APPLICATION NO.	FILING DATE	FIRST NAMED INVENTOR	ATTORNEY DOCKET NO.	CONFIRMATION NO.
10/033,970	12/20/2001	Karl Hansen	24,954-25	9112

Office Action Summary

DETAILED ACTION

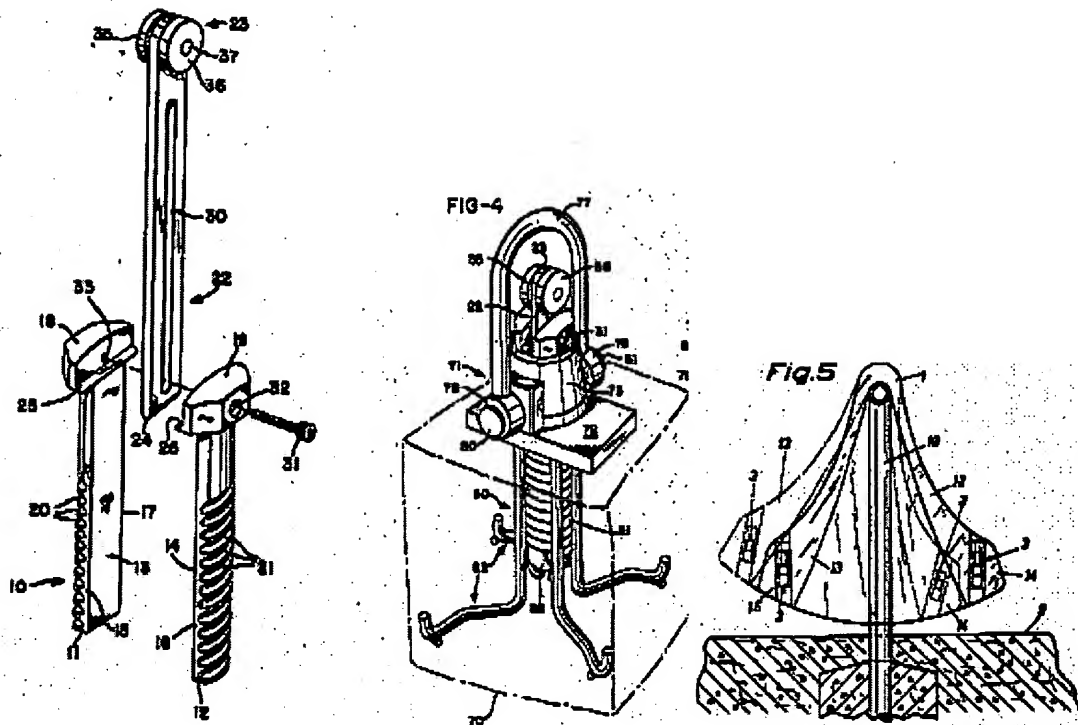
The drawings are objected to because **numerous reference numerals have been used to identify all variations of the same name part. As but one example, a planar element "12" is different variation in all of Figs. 1, 2, and 14-20.** Corrected drawing sheets in compliance with 37 CFR 1.121(d) are required in reply to the Office action to avoid abandonment of the application. Any amended replacement drawing sheet should include all of the figures appearing on the immediate prior version of the sheet, even if only one figure is being amended. The figure or figure number of an amended drawing should not be labeled as "amended." If a drawing figure is to be canceled, the appropriate figure must be removed from the replacement sheet, and where necessary, the remaining figures must be renumbered and appropriate changes made to the brief description of the several views of the drawings for consistency. Additional replacement sheets may be necessary to show the renumbering of the remaining figures. Each drawing sheet submitted after the filing date of an application must be labeled in the top margin as either "Replacement Sheet" or "New Sheet" pursuant to 37 CFR 1.121(d). If the changes are not accepted by the examiner, the applicant will be notified and informed of any required corrective action in the next Office action. The objection to the drawings will not be held in abeyance.

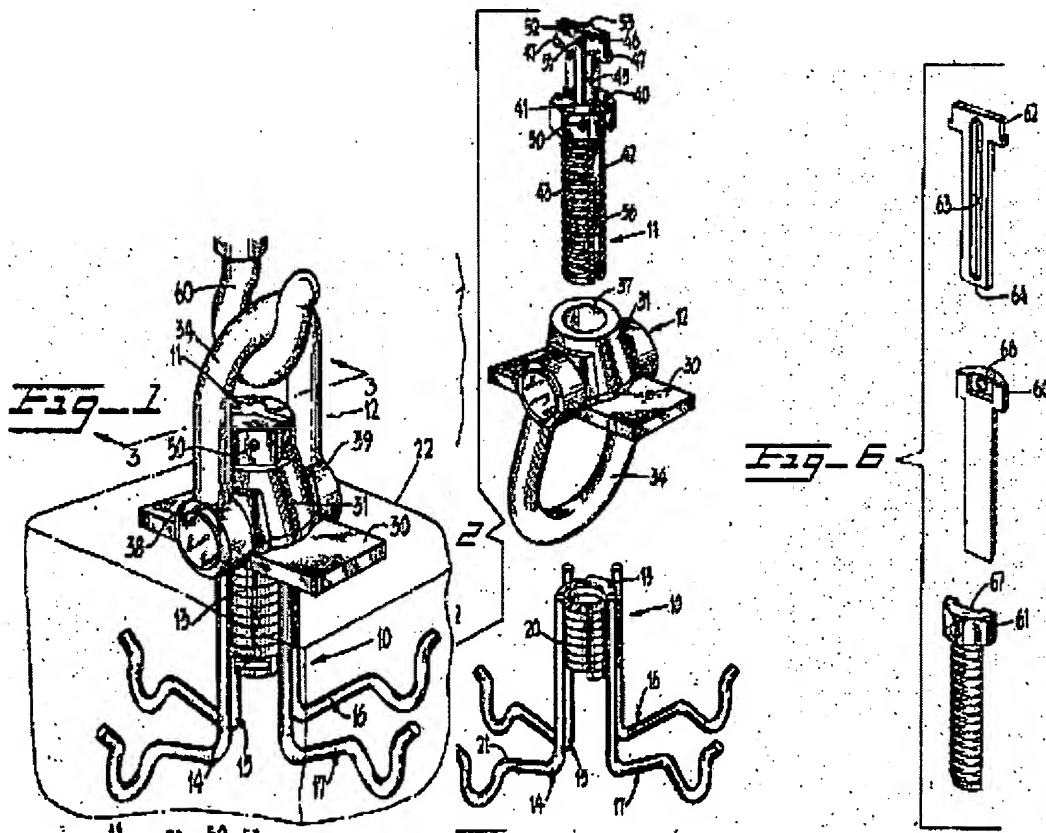
With respect to claim 27, Strong discloses an apparatus for joining two members via a threaded coupling member (Figs. 1, 2, 6) the apparatus comprising a first member (45) having a non circular aperture (63) disposed proximate an edge; an elongate threaded coupling member

(11) having an external thread set (42, 43) and a non-spherical engaging portion (65), the engaging portion (65) preventing rotation of the first member (45) relative to the coupling member (11) when the engaging portion (65) is inserted into the aperture (63) of the first member (45), and a second member (20) having an internal thread set sized to cooperate with the external thread set of the threaded coupling member (11), said internal thread set operatively receiving a portion of both the external thread set of the threaded coupling member (20, 21) and a portion of the first member (45) to secularly bind the first member (45) to the second member (20).

With respect to claims 28-31, Strong discloses (Figs. 1, 4) that the non-circular aperture is a slot aperture (63) having a pair of generally planar walls; wherein the engaging portion (65) includes a pair of generally parallel planar surfaces being in contact with the pair of planar walls of the slot aperture (63) when the engaging portion is inserted into the aperture; wherein the coupling member (65) is T-shaped; and wherein the coupling member (11) includes a pair of co-
